Response to RAIs on WCAP-17788
Volume 4 - CE Plants

ANP-3583NP

LICENSING REPORT

AREVA Inc.

Figure RAI-4.9-1: CE Base Case – Heat Transfer Mode at the PCT Node

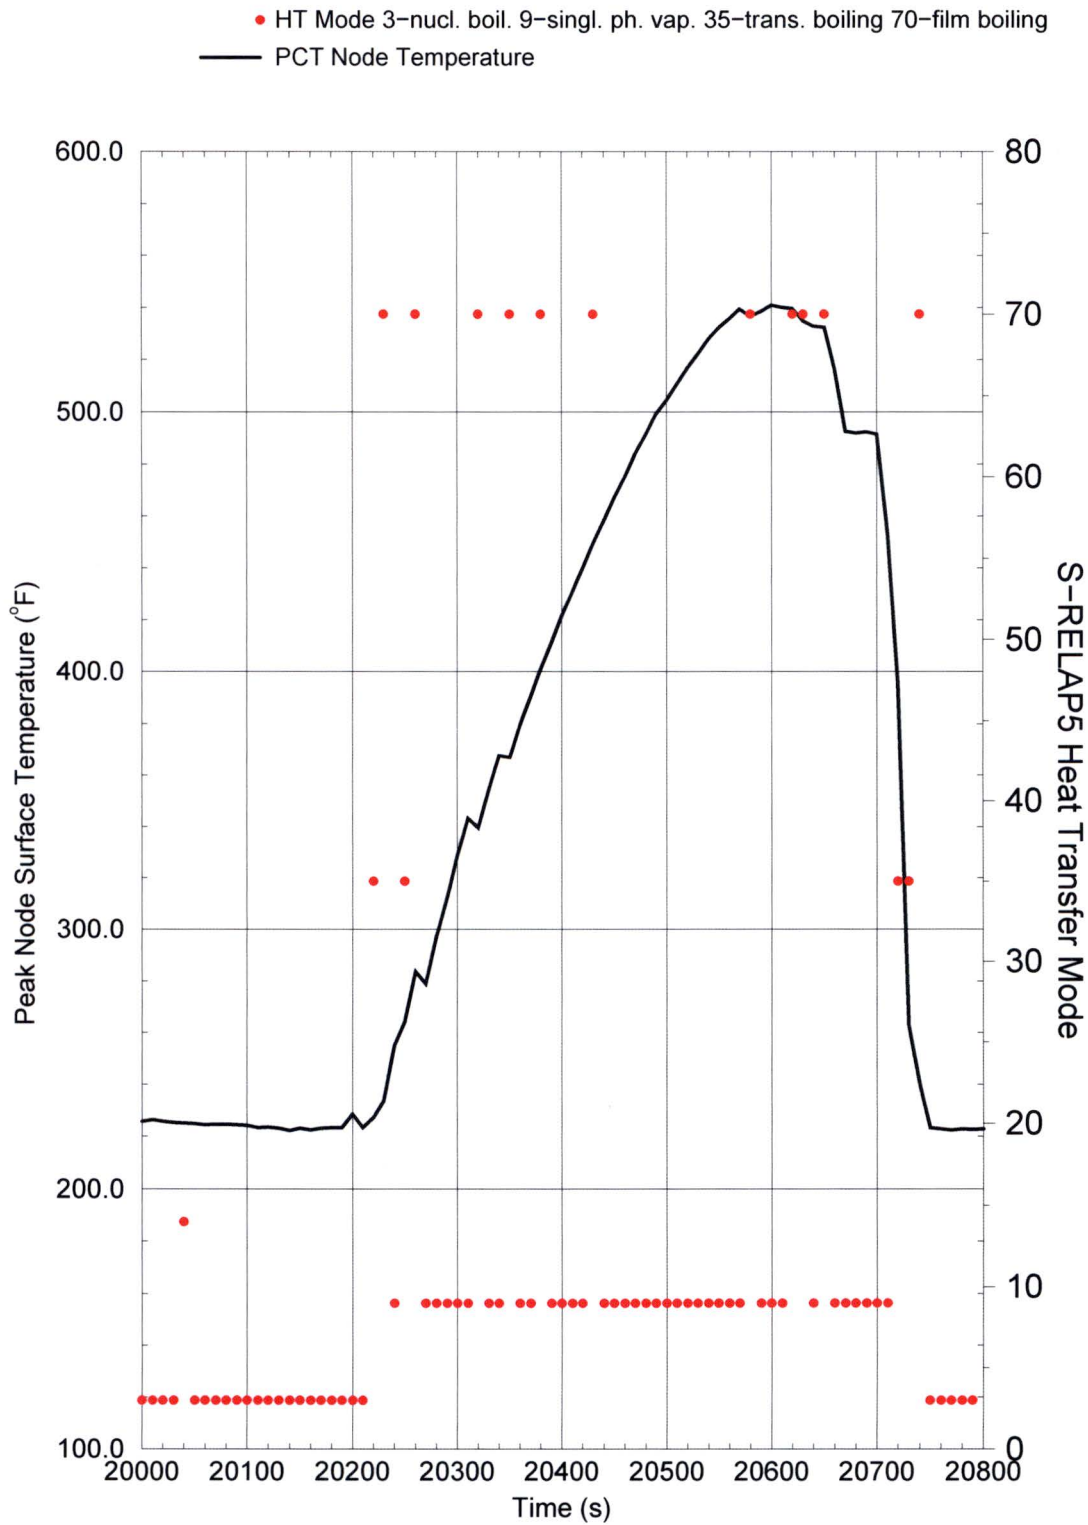
- (d) Identify the closure heat transfer correlations associated with the heat transfer regimes identified as controlling with regard to the PCT values in Figures 8-16 and 9-15. Provide the ranges of applicability of these correlations and compare them against the predicted core limiting T-H parameters.
- (e) Identify the constitutive correlations for computing void fraction and any predicted entrained droplets/liquid film fields, as applicable, associated with the two-phase flow regime predicted at the PCT location and time of its occurrence. Provide their ranges of applicability and compare them against the predicted core limiting T-H parameters.

As noted in the response to Part a, the PCT occurs around 20580 seconds. The flow regime at the PCT node is expected to be mist flow and the heat transfer conditions to correspond to single-phase vapor, as illustrated below in Figures RAI-4.9-1 and RAI-4.9-2. The data requested is provided for the 20600 seconds major edit for data extraction convenience. At 20600 seconds the cladding temperature at the PCT node is 540.9 °F, with the temperature excursion still close to the peak and thermal-hydraulic conditions similar to the time of PCT. The data requested are summarized in table RAI-4.9-1.

Parameter	Value	Comments
Fuel rod local linear heat generation rate (kW/ft)	0.073	
Predicted two-phase flow regime	Mist flow	Figure RAI-4.9-2
Axial vapor mass flow rate - inlet (lbm/s)	0.2402	Figure RAI-4.9-3
Axial vapor mass flux - inlet (lbm/s-ft ²)	0.9653	Figure RAI-4.9-4
Axial vapor mass flow rate - outlet (lbm/s)	0.1866	Figure RAI-4.9-5
Axial vapor mass flux - outlet (lbm/s-ft ²)	0.7501	Figure RAI-4.9-6
Axial liquid mass flow rate (lbm/s)	0	
Axial liquid mass flux (lbm/s-ft ²)	0	
Cross-flow vapor mass flow rate (lbm/s)	0.0532	Figure RAI-4.9-7
Cross-flow vapor mass flux (lbm/s-ft ²)	0.1586	Figure RAI-4.9-8
Cross-flow liquid mass flow rate (lbm/s)	0	
Cross-flow liquid mass flux lbm/s-ft ²	0	
Axial vapor velocity (ft/s)	23.65	in the node
Axial liquid velocity (ft/s)	0	no liquid present
Cross-flow vapor velocity (ft/s)	24.72	at the junction
Cross-flow liquid velocity (ft/s)	0	no liquid present
Wall heat transfer mode	Single-phase vapor	Figure RAI-4.9-1

Figure RAI-4.23-15: Vessel Side Break Equilibrium Quality Comparison

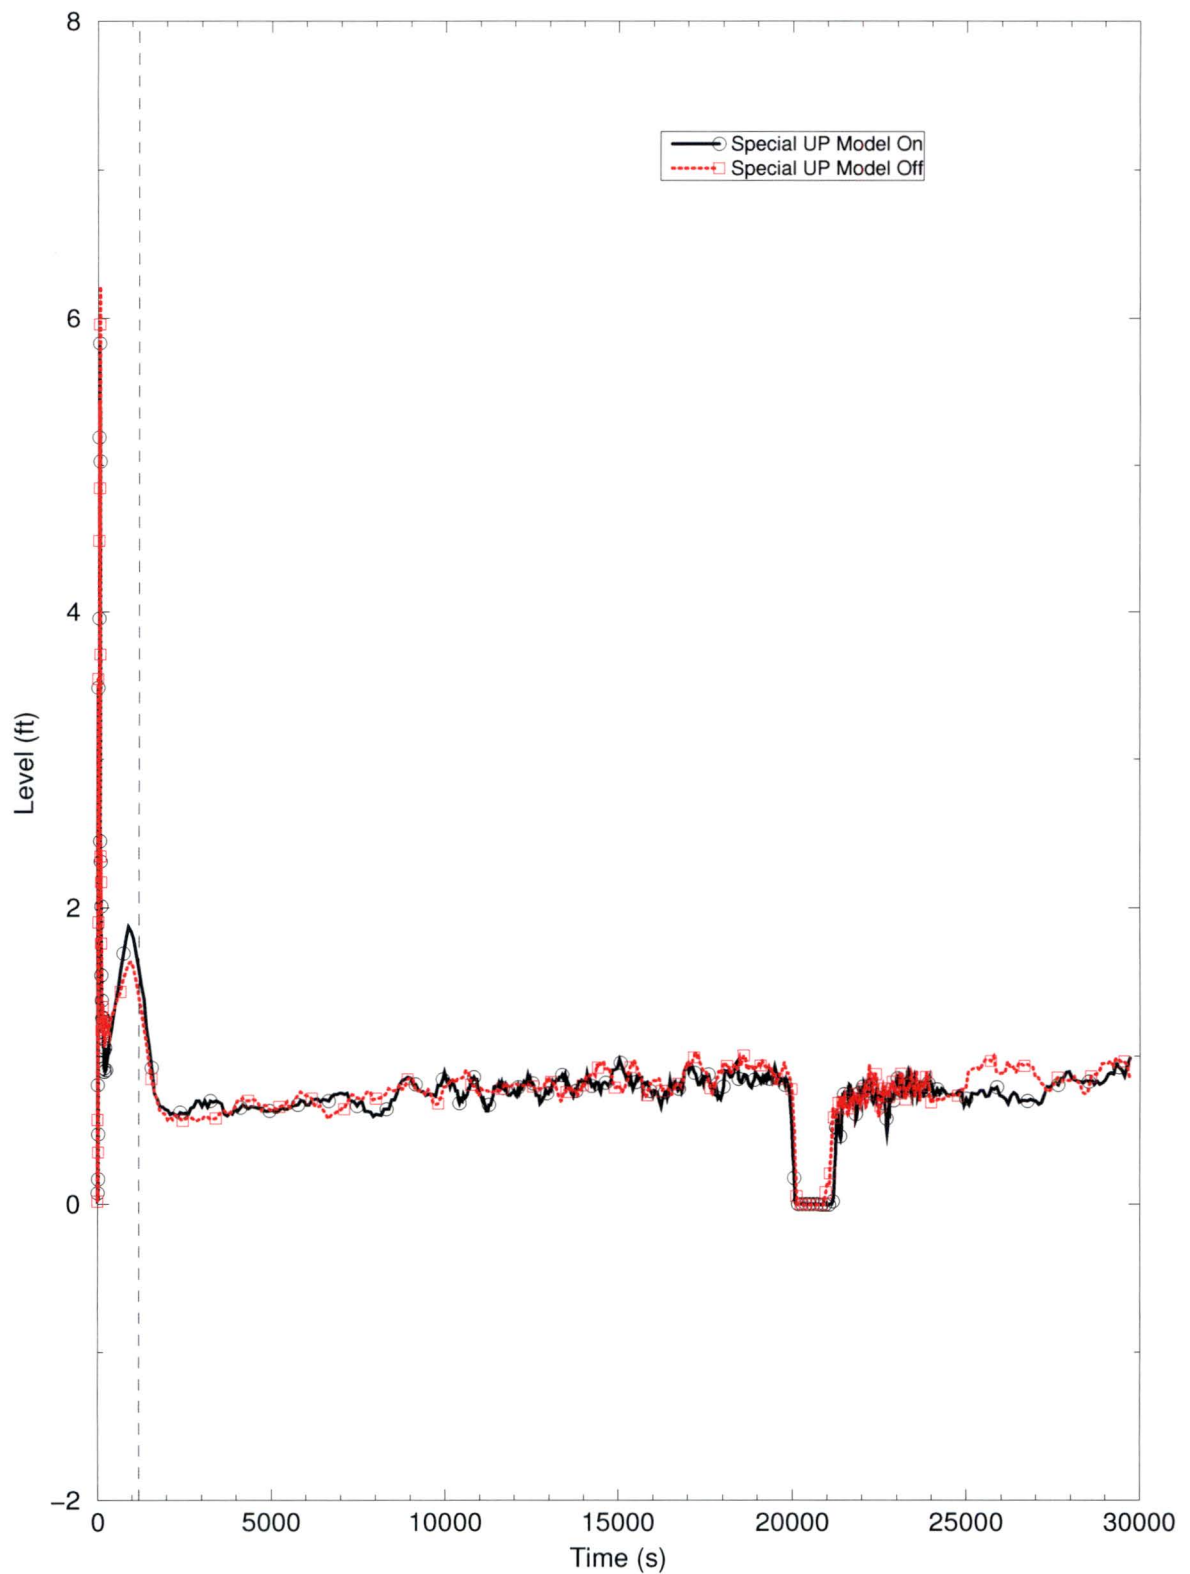
- (iv) Predicted pressure difference between the upper plenum cell connected to the broken hot leg pipe and the containment backpressure.
- (f) Figure 1 below compares predicted exit qualities for the original analysis of Case 1 used to determine t_{block} for the CE plant category as documented in Section 10 and the revised analysis in Erratum, submitted with the February 12, 2016, letter OG-16-42 ($t_{\text{block}}=20,000$ seconds). It is noted that the results are significantly different following the simulated blockage time in each analysis. The results also differ during some time periods prior to 15,000 seconds, which is the earlier of both simulated t_{block} times. Describe why the results prior to 15,000 seconds are not consistent between the two cases and state which case presents the correct values. Provide similar information for the time period after blockage is simulated. Please describe why the results fluctuate significantly and justify that the code performance provides a valid representation of the system.

In order to better compare the figures in question, the break equilibrium quality is compared between the original WCAP-17788-P submittal and the errata submitted in the February 12, 2016 letter OG-16-42 (Reference 4.23-14) in Figure RAI-4.23-15 and Figure RAI-4.23-16. It can be seen that the SG side of the break matches between the two cases until the time of t_{block} . On the other hand, the vessel side of the break matches until approximately 11,000 seconds, where the quality starts to differ. The only differences between these two cases during this period is the requested major edit frequency and the restart edit frequency. For the original case, the major edit and restart edit were requested every 1,000 seconds during this period (from 10,000 seconds until t_{block}) whereas the revised case requested the edits every 10,000 seconds during this same period. As these cases are long and the output files are large, this was an attempt to make the files more manageable in size. The major edit and restart edit frequency has some potential to alter results since the code adjusts its time step to cause a major edit (or a restart edit) at the requested point. The change in time step can lead to a different solution. Although some intermediate trends can change with a modified time step, the overall conclusions remain the same.

In RAI 4.1b, the CE TH analysis is revised to include several updates and is the current and correct analysis for review. Sensitivity studies were performed on t_{block} and the results are confirmed to be identical prior to t_{block} , as expected.
